Hillsborough County Florida

STAFF REPORT

SUBJECT:	PRS 21-0160 RU/S	PLANNING AREA:	Ruskin
REQUEST:	Minor Modification to a Planned Development	SECTOR	South
APPLICANT:	Jacob T. Cramer, Stearns Weaver Miller		
Existing Zoning : PD 16-1336		Comp Plan Category: SMU-6

PRS 21-0160

Figure 3 – Sheet 2 of 2 PD Plan – BUFFERS - PROPOSED PLANTINGS AND LOCATION

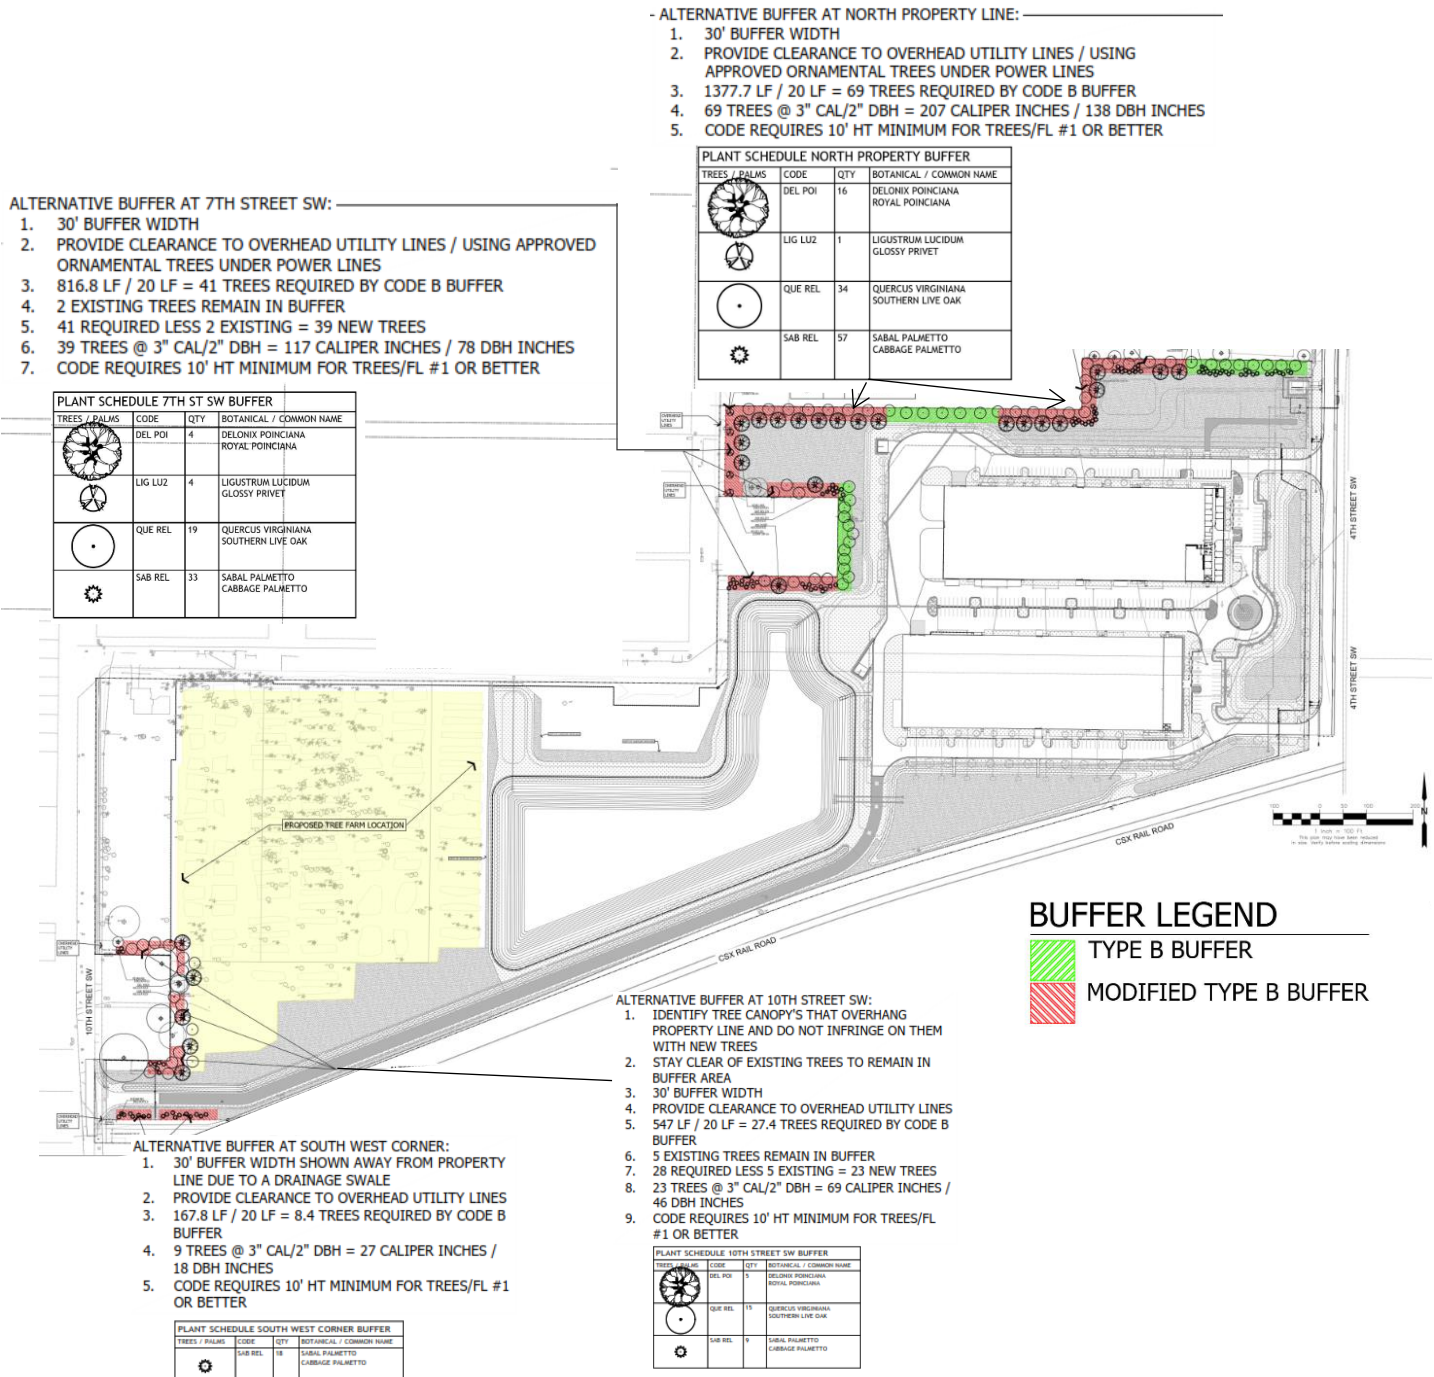
Sheet 2 of 2 of the GSP shows the areas where the approved Type B landscaping is being provided (green) and the areas where the alternative landscaping (red) is proposed as part of this minor modification.

Natural Resources staff reviewed the request and does not object. The proposed Alternative Screening Plan for the required Type B buffer does not meet the Land Development Code requirements of Section 6.06.06.B.4. Type B screening trees must be evergreen shade species spaced not more than 20 feet apart within the buffer.

The Alternative Screening Plan proposes a row of live oaks, which are evergreen shade trees, spaced at 40 feet apart, with areas of royal poinciana trees and clusters of sabal palm trees in a second row with the trees staggered between the live oaks. The proposed royal poinciana trees are not considered evergreen, and the proposed sabal palms are not shade species.

However, the applicant has revised the Alternative Screening Plan to provide live oaks at the required 20 feet on center in the areas where a single-family residence will have a direct view of the commercial buildings. The areas of the buffer where the royal poinciana trees and sabal palms are proposed are

limited to areas where there is dense vegetation existing on the neighboring property, or the neighboring property has a view of a pond or other vegetation on the subject commercial property.

Therefore, Natural Resources staff feels the Alternative Screening Plan meets the intent of the screening requirement in Section 6.06.06.B.4 of the Land Development Code.
